SPECIAL
RADIO SERVICE
BULLETINS

THOMAS A EDISON, INC.
ORANGE N.J.

SPECIAL SERVICE BULLETIN FOR EDISON RADIO SERVICE ENGINEERS

ELIMINATION OF HUM
TO ACCOMPANY
SERVICE BULLETIN #1

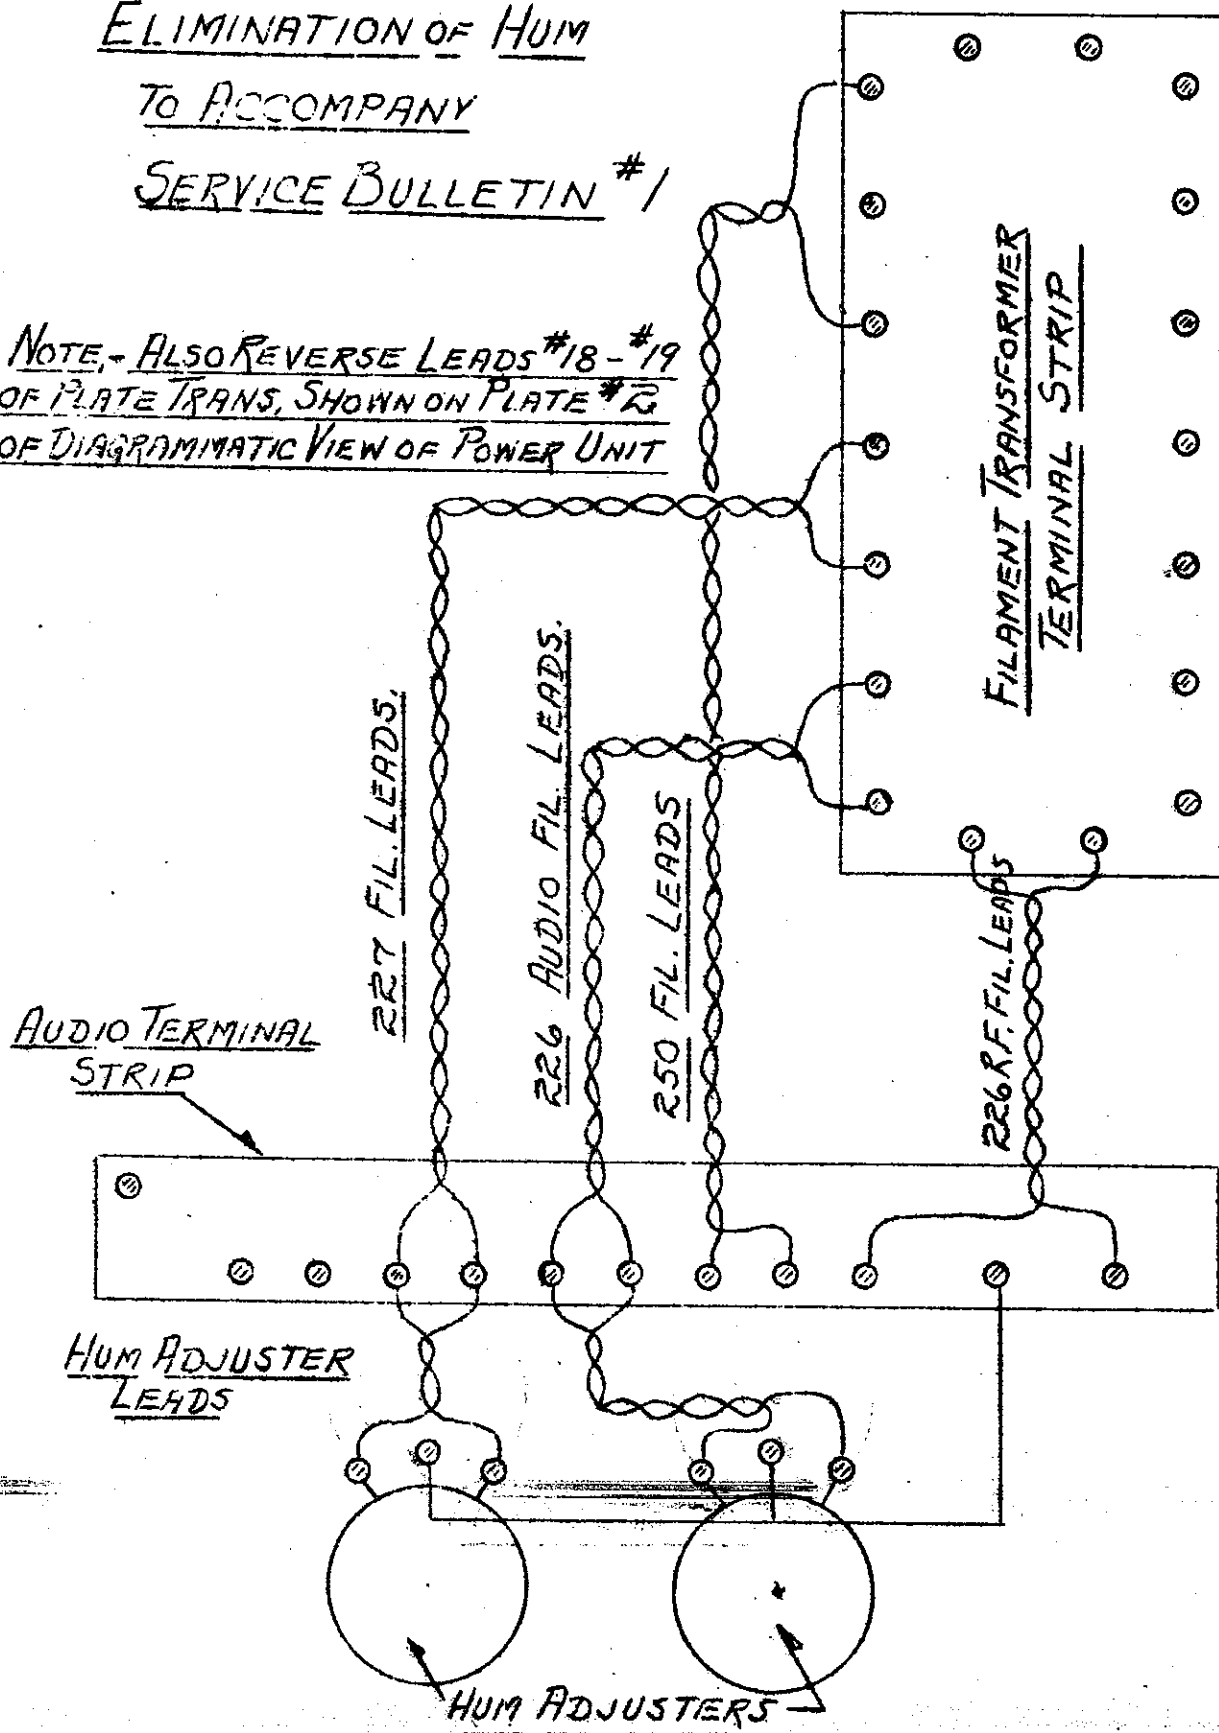
SUBJECT: "Elimination or the reduction of hum level in JR and JC chassis."

1. Remove power pack unit from chassis.
2. Reverse the secondary leads on the plate (power) transformer. With the power pack in it's normal position you will find these leads at the lower, bottom end of terminal board. The terminal lug at extreme bottom has attached to it two leads, one green covered wire and a yellow wire with red tracer, remove both of these leads and place them on the terminal just above and next to lowest terminal. Of course, placing the lead from second terminal on lowest terminal.

3. Remove the five bolts securing the filter condenser to power pack frame, permitting access to and removal of all A.C. leads.
4. The filament leads to the 281 rectifier tube must be removed from cable and twisted together, then replaced in former position, back of filter condenser position.

5. Twist the 110 volt A. C. feeders, which connect the plug and line switch panel to primaries of power transformers. To do this, of course all cable lacing must first be removed from wires. After the twisting operation it will be unnecessary to replace lacing.

6. Braid the three leads which run from line switch points to primary terminals of Plate transformer.
7. Replace the Power pack unit, bolting to chassis frame.

8. It is advisable, because of color code used in cable from audio unit to power pack unit, to replace all these cable leads. Then, removing the R.F. (red) 226 filament leads, that is unsolder them at transformer terminal block, pull them back along cable route, twist then and replace in regular position, soldering them to same terminals on transformer terminal block.

9. In the same manner twist the 227 detector filament leads.
10. In the same manner twist the 226 audio filament leads.

11. Remove the hum adjuster leads at the audio terminal strip. Twist these leads for each adjuster and resolder ends to terminal board.

12. Unsolder the pilot light leads at the pilot light. Pull the leads through condenser platform. Twist these leads and pull through platform hole and resolder to pilot light terminals.

NOTE, - ALSO REVERSE LEADS #18 - #19
OF PLATE TRANS, SHOWN ON PLATE #2
OF DIAGRAMMATIC VIEW OF POWER UNIT

CONNECTIONS FOR EXTERNAL AND
SEPARATELY EXCITED DYNAMIC SPEAKER

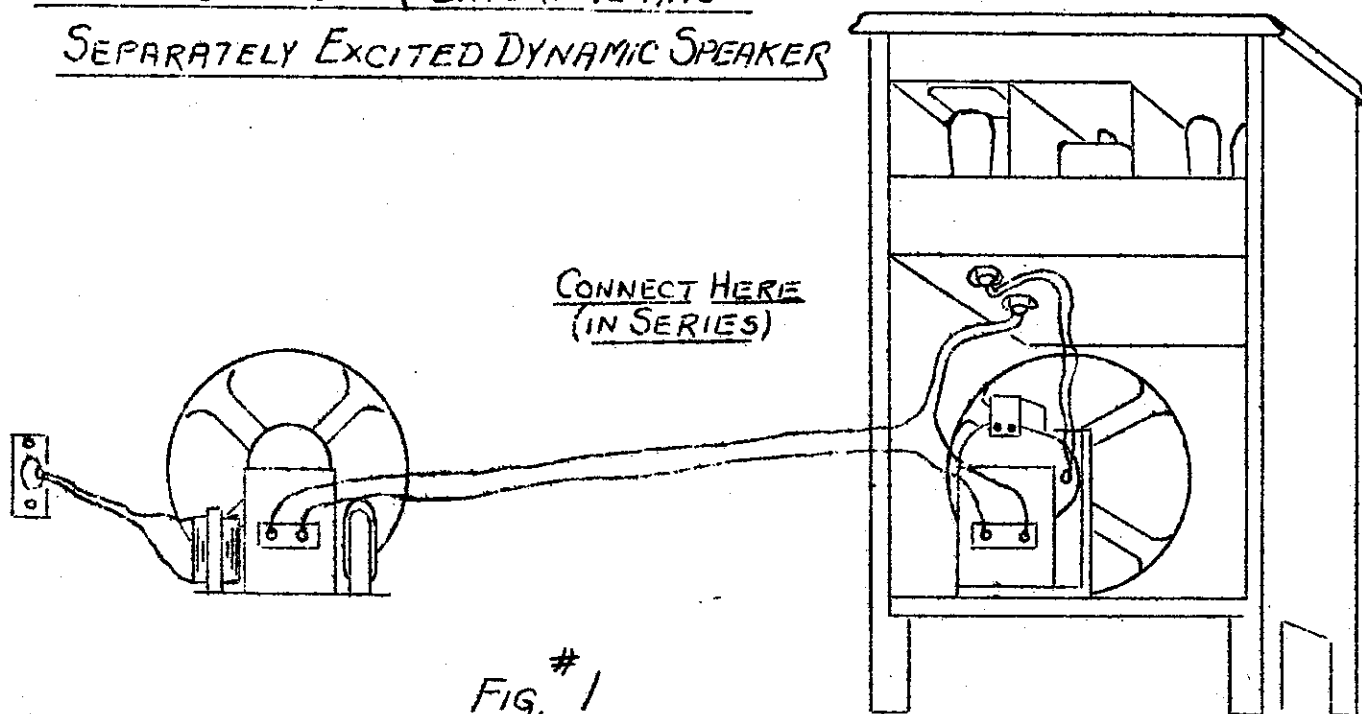
SUBJECT: "The use of an external and separately excited dynamic speaker in connection with Models R-2; R-1 and C-2".

1. Connect voice coils in series.
2. External or additional speaker must be separately excited, that is the field of the external speaker must be excited direct from power line and must not be hooked up in connection with speaker field in set.
3. Approximately five percent loss of volume may result with this duplex speaker arrangement.
4. Such an installation has been arranged satisfactorily by an Orange dealer and is employed in a local hotel where the use of an additional speaker is desired, in a room removed from the set itself, and at an approximate distance of seventy-five feet. In this particular instance a Fada Dynamic Speaker was employed with excellent results.
5. This case is merely cited for your information and guidance in the event you are faced with similar problems in the field.

SKETCH SHOWS CAUSE FOR LOSS OF VOLUME IN PICK-UP

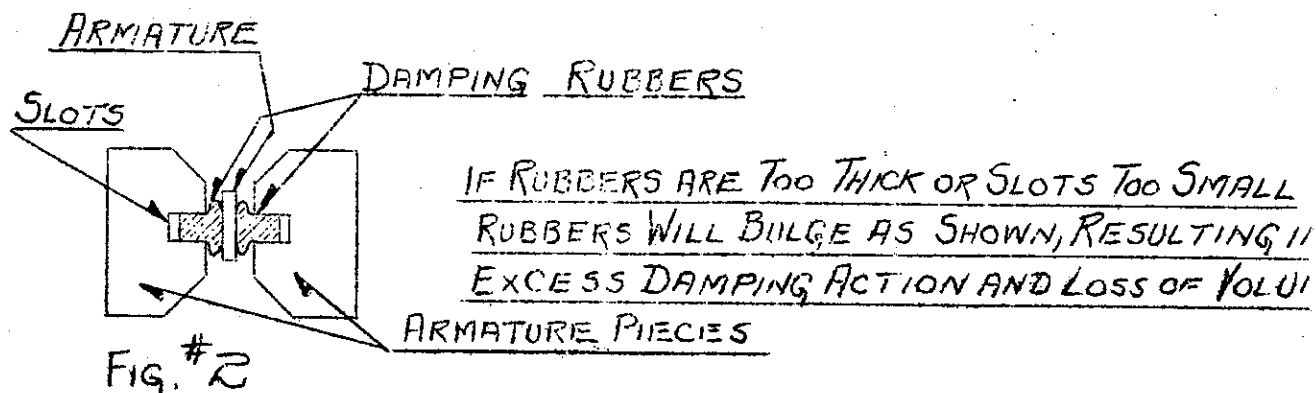
SUBJECT: "Loss of volume in phonograph electric pick-ups".

(a) Excessive damping, The pole piece slots may be too small or too narrow, resulting in improper damping action or prevention of proper damping adjustment by means of the adjustment provided for this purpose. That is, damping may be increased to an excessive amount but decreased damping will not result from change in adjustments provided, the narrowed slots in pole pieces preventing damping rubber from returning or resuming its natural position in slotted recess. To correct this condition in an emergency it is recommended that pole pieces be removed and the slots widened by filing. However, great care must be exercised in this operation, using a platinum file, trying the damping rubber frequently to insure a "Snug" fit,

(b) Excessive damping and subsequent loss of volume may also result from damping rubber which may be too thick. The result being the same as in (a). The remedy, likewise being the same as in (a).

NOTE, - TO CORRECT THIS CONDITION WIDEN SLOTS
BY FILING SIDE WALLS, USING PLATINUM FILE OR EXTRA
FINE FILE, PERMITTING FREE MOVEMENT, IN AND OUT
OF DAMPING RUBBERS.

VIEW OF DYNAMIC SPEAKER

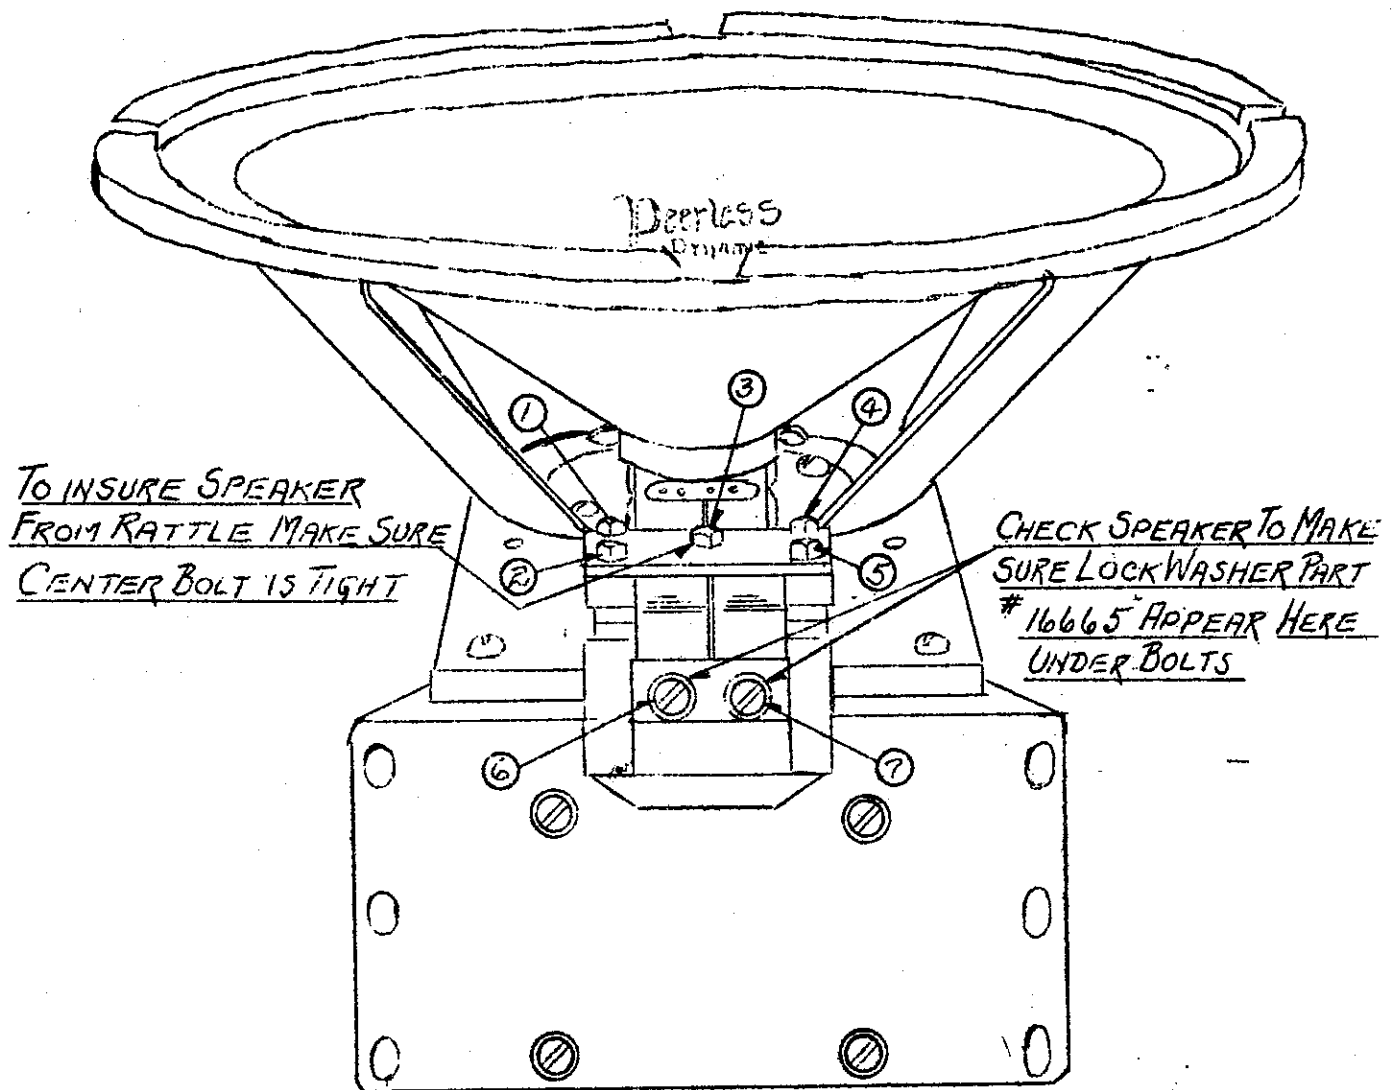
SUBJECT: Lack of volume on Dynamic speakers.

One of our field Service Engineers has been consistently reporting that he finds speaker bolts very loose. In order to get the best volume and reproduction the following bolts must be drawn up tight.

1. Voice coil holding bolts numbered 1,2,3, 4 and 5 on attached diagram.

2. Voice coil contact bolts numbered 6 and 7 on same diagram.

① TO ⑤ VOICE COIL HOLDING BOLTS

⑥-⑦ THESE CONTACT BOLTS MUST BE TIGHT.

FIGURE #1

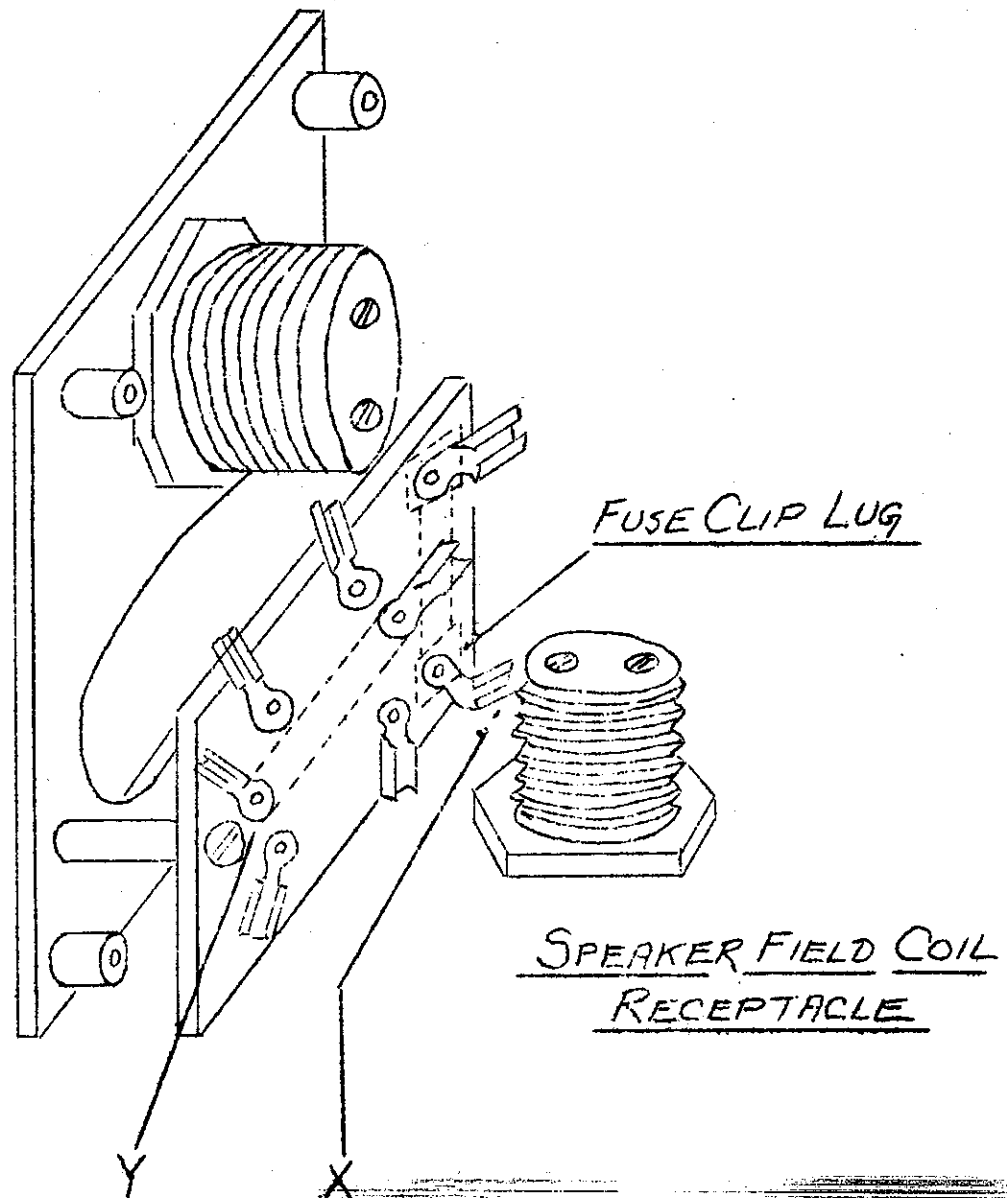
SUBJECT: "Burned out Antenna Coils".

1. A Western distributor reports a number of burned out antenna primary coils. Aside from Atmospheric discharges such as lightning we prescribe the following possible reasons which, under certain conditions, may contribute to the burning out of antenna coils.

2. The Attached figure indicates the location of possible short in chassis which will result in burned out primary IF THE GROUND WIRE IS ATTACHED TO ANTENNA POST OR IF ANTENNA ITSELF BECOMES GROUNDED.

3. To eliminate possibility of such ground-push connecting lugs as far away as possible from field coil plug shell, at X and from screw head, at Y. See figure 1.

FIG. #1

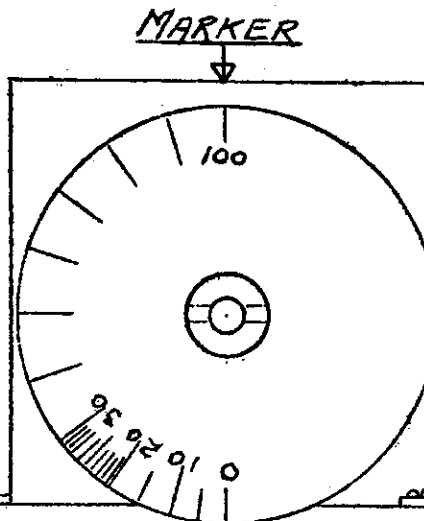
1. For balancing, a very weak signal is desired. To secure this, use a short length of wire attached to antenna post.
2. Rotate dial to 100 position, condenser plates should now be fully enmeshed. Fix dial marker, as in figure 1, marker indicating exactly 100 on dial.

ROTATE CONDENSERS TO POSITION OF MAXIMUM CAPACITY. PLATES FULLY ENMESHED. SET MARKER DIRECTLY ABOVE 100. MAKE SURE POSITION OF MARKER REMAINS FIXED. ROTATE DIAL TO A STATION, PREFERABLY BETWEEN 20 AND 30. PLACE SWITCH IN REG. POSITION. INCREASE VOLUME TO "NEAR REG." THEN ADJUST EACH COMPENSATOR FOR MAXIMUM VOLUME.

TO ACCOMPANY BULLETIN #15

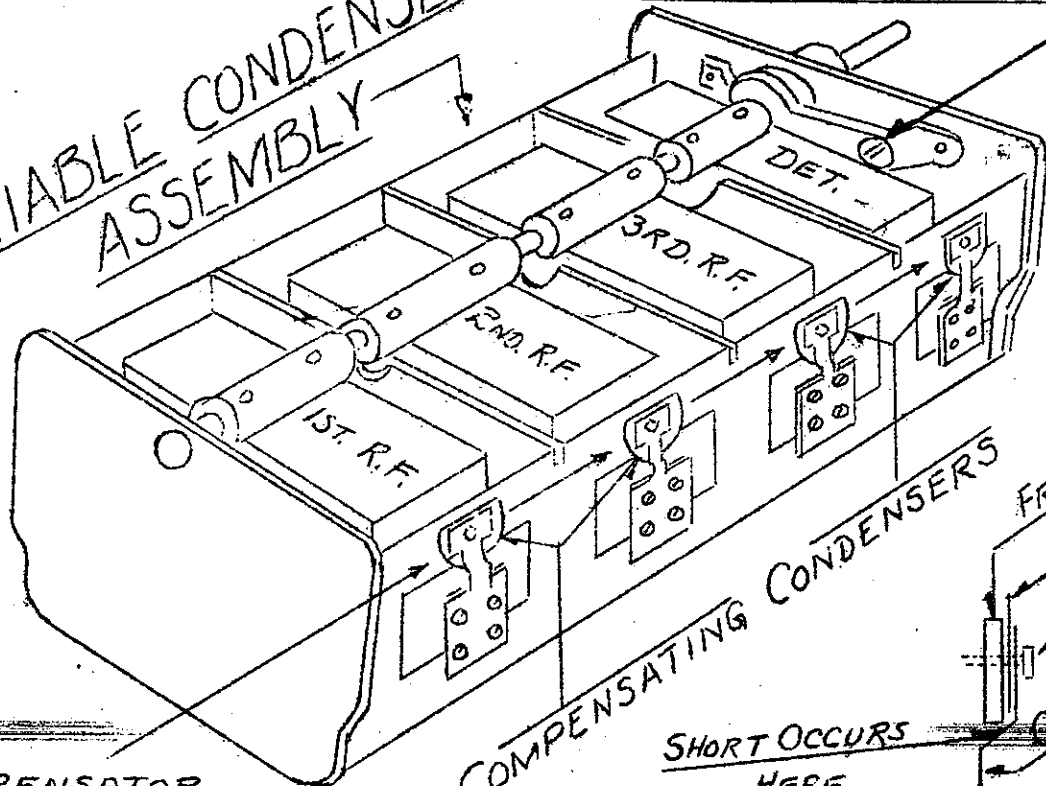
4. Move regeneration Switch to Regenerative Position. With volume control turned up as much as possible but always just below the "spilling point", use balancing tool, turning the detector compensator adjustment screw, all the way in or out to locate the point of maximum volume. As the balancing tool is removed from adjustment screw a slight decrease in volume may be noticed. If so, set up or tighten the adjustment screw a trifle until maximum volume results with balancing tool removed. This condition will hold, probably with the remaining adjustment screws.

5. Do not change dial setting. Next and in a similar manner adjust the (adjoining) third R. F. compensating condenser - FOR MAXIMUM VOLUME.
6. Likewise adjust the second and first R. F. compensating condensers - FOR MAXIMUM VOLUME.

2. In some cases the radio frequency compensating condensers are set up tightly (maximum capacity) against the condenser frame. Sometimes this tight adjustment is necessary for accurate balance, particularly on the detector compensator.

3. Then, it may be possible that a "near short" or complete short will exist at the bend in the compensator plate, from the bending point to condenser frame. If a "near short" exists, that is if the compensator plate is practically touching the condenser frame, a slight jar or vibration, such as occurs when one walks across the floor will result in a complete short and the set stops operating. Then again, another such jar or vibration will remove the short and set will voluntarily begin operating.

4. If such a condition is found remove the compensator adjustment screw. Pull out the compensator plate and bend downward slightly, so that when replaced the bent portion of compensating plate cannot contact with the frame and this trouble will forever be eliminated.

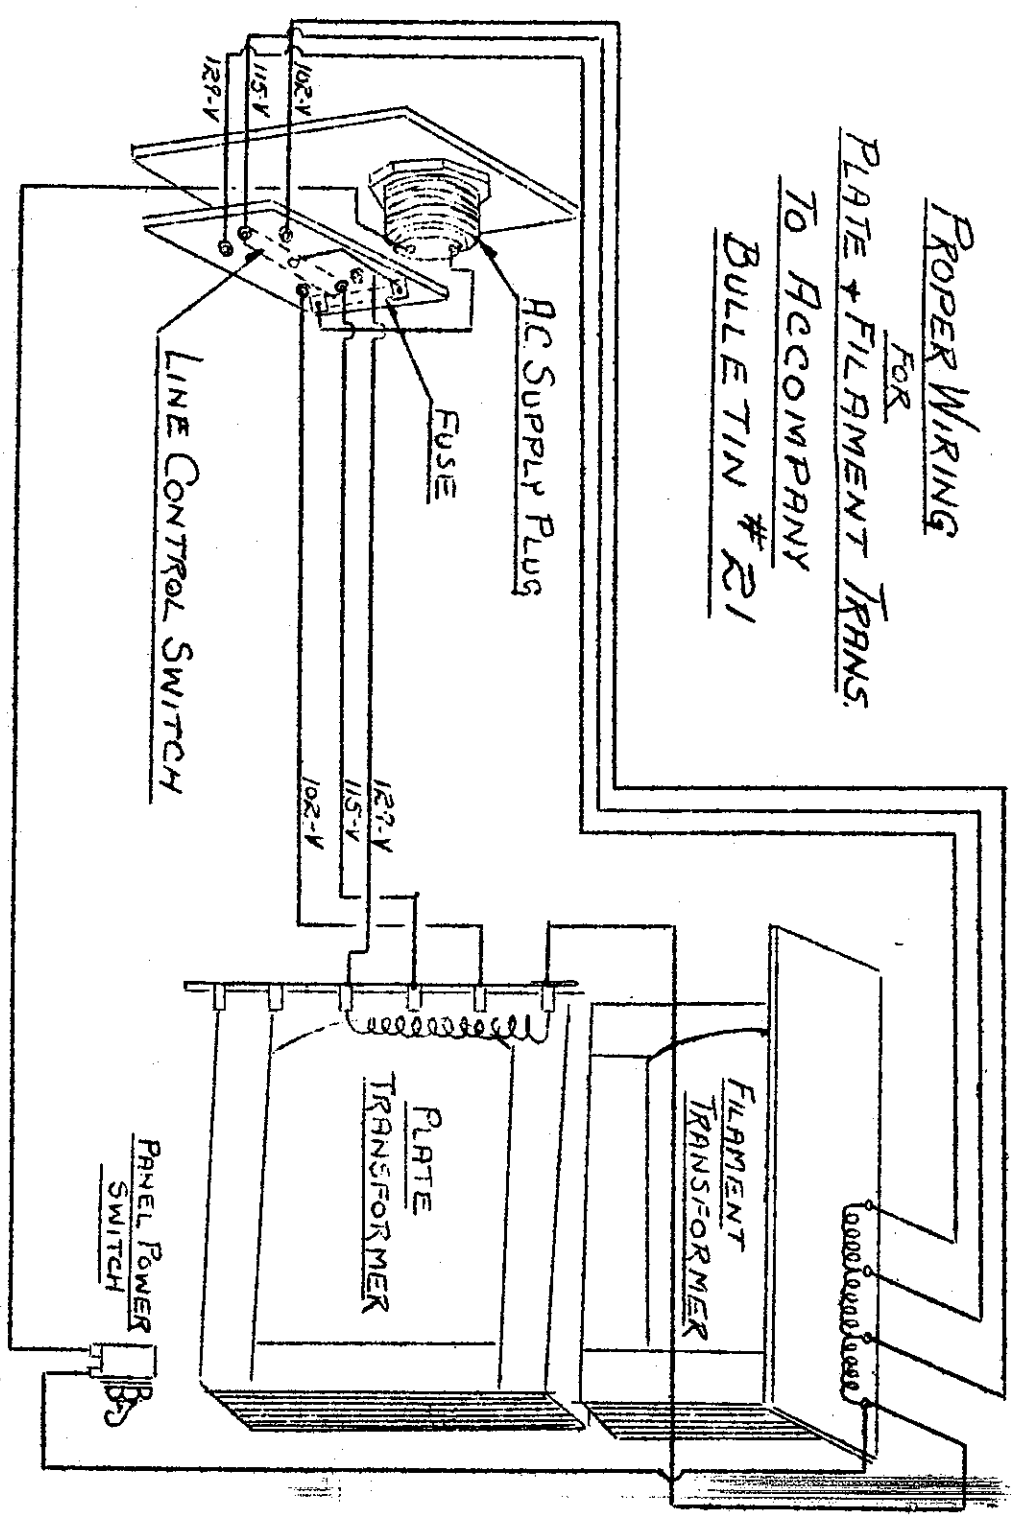
SUBJECT: "Plate transformer improperly connected."

1. Several reports have come to us stating that the primary of plate transformer was not connected in parallel with the primary of the filament transformer, but connected directly to the alternating current line.

2. As a result, the "on and off" switch shuts off only the filament supply transformer, while the plate transformer is left on at all times.

3. This condition is usually recognized by the fact that the Set, instead of stopping immediately when shut off continues to play for a few seconds, or in other words, as long as the filament holds sufficient heat to operate.
